Washington State
Department of Transportation
Paula J. Hammond, P.E.
Secretary of Transportation

May 12, 2008

RE: Structural Examination of Woodland State Airport

Photo #1
Building A, Hangars 1 Thru 3

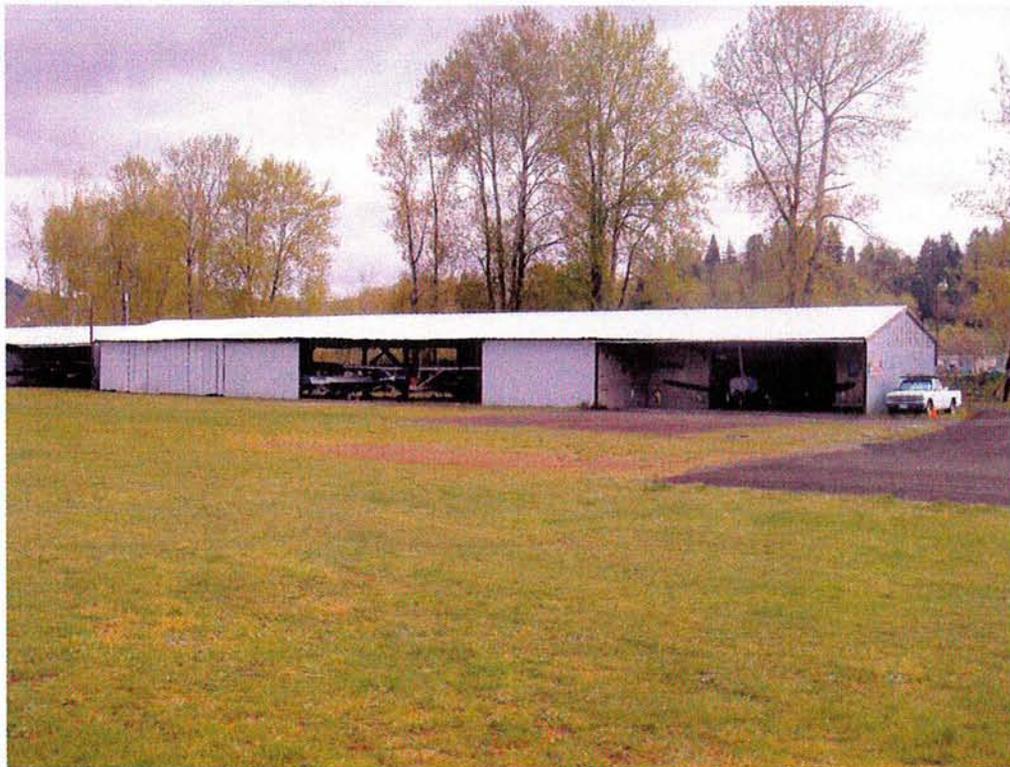
supported at the center as well as the front and rear post lines. Roof purlins consist of 2x6 members at 2' to 2'-6" on center single spanned up to 20' with a galvanized corrugated metal roof. The exterior posts generally consist of creosote treated double 3x6 members and interior posts consist of pressure treated 6x6 members. The posts are embedded into the ground and are situated at an alternating 10' and 20' on center spacing with the exterior post lines enclosed by galvanized corrugated metal siding. (See Photos #1 and #2)

Photo #6
Multiple Band-Aids

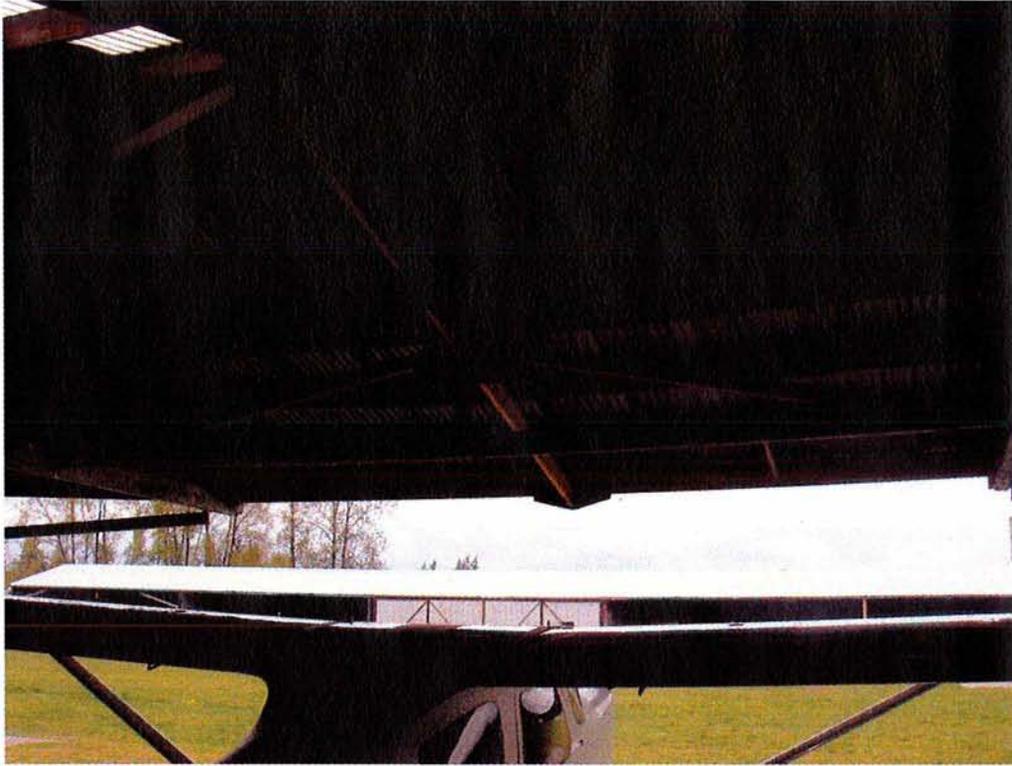
In several areas the truss type frame work has been modified further with additional vertical and diagonal scab members and or strapping in various configurations to provide additional rigidity. On the cantilevered end side of the framework, additional diagonal knee braces have been installed in various configurations. These braces typically consist of single or double 2x6's attached to the interior post and out to near mid span of the framing. These connections also vary with through bolts in some locations and minimal nailing in others. Many of the installed knee braces are buckling out of plane up to 1" or more and several nailed connections are beginning to separate. At a few locations, 1/2" steel tie rods with angle clips, between the top and bottom chords, were installed in place of knee braces. The angle clips are bending slightly and crushing at the back of the through bolt connection. (See Photos #5 and #6)

Photo #10
Mezzanine With Enclosed Storage Space, Hangar 13

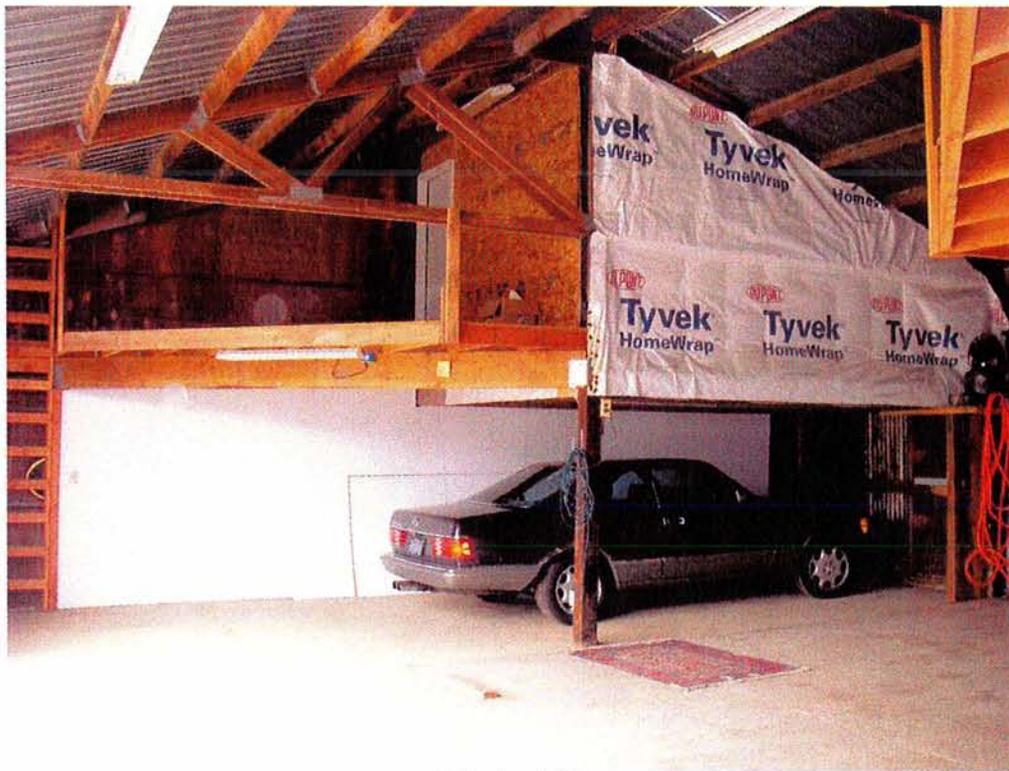
In hangar 13, wood framed storage mezzanines have been constructed at each side of the bay running from the front to the rear wall and are accessed by ladders. On the south side of the bay, there is an enclosed storage or office space supported by the mezzanine. Framing for the mezzanines consists of 3/4" plywood over 2x6 and 2x6 rough sawn members spanning up to 15' between wall lines and wood beams. The beams are attached to the existing posts with field bent Simpson Strong Tie brackets. (See Photo #10)

On the interior of hangar 13, the recently wood framed mezzanines do not outwardly appear to meet current code requirements. Typical framing for this purpose is usually required to be designed for loads in the area of 50 to 100 psf. to accommodate office or light storage loads.
